Sundry Print Report

Well Name: POKER LAKE UNIT 21 Well Location: T24S / R30E / SEC 21 / County or Parish/State:

Well Number: 177H Type of Well: CONVENTIONAL GAS Allottee or Tribe Name:

Type of Action: APD Change

WELL LOCATION AND ACREAGE DEDICATION PLAT

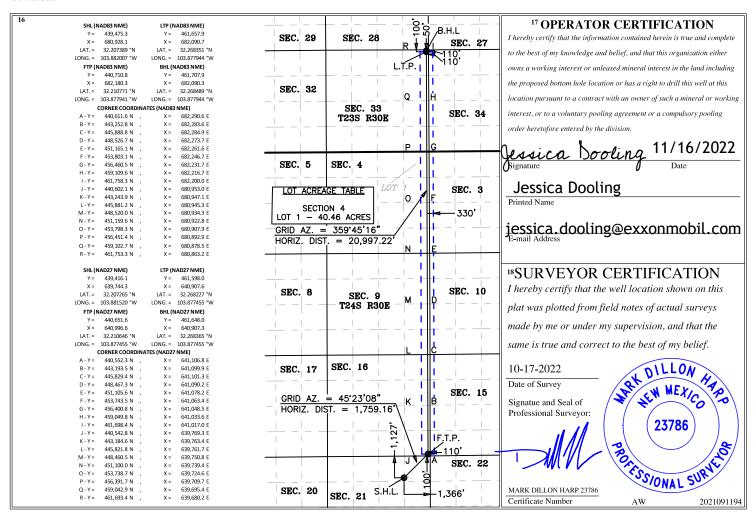
Procedure Description: ** Pool Change, Bottom Hole Location Change, First and Last Take Point Changes XTO Permian Operating, LLC requests permission to make the following changes to the original APD: Change Pool from 98220 Purple Sage; Wolfcamp to 97798 Wildcat G-06 S243026M; Bone Spring No Additional Surface Disturbance. Change BHL from 200'FNL & 1650'FEL to 50'FNL & 110'FEL, Section 33-T23S-R30E Change FTP fr/384'FNL & 1630'FEL to 100'FSL & 110'FEL Change LTP fr/329'FNL & 1650'FEL to 100'FNL & 110'FEL Attachments: C102 Drilling Program Directional Plan
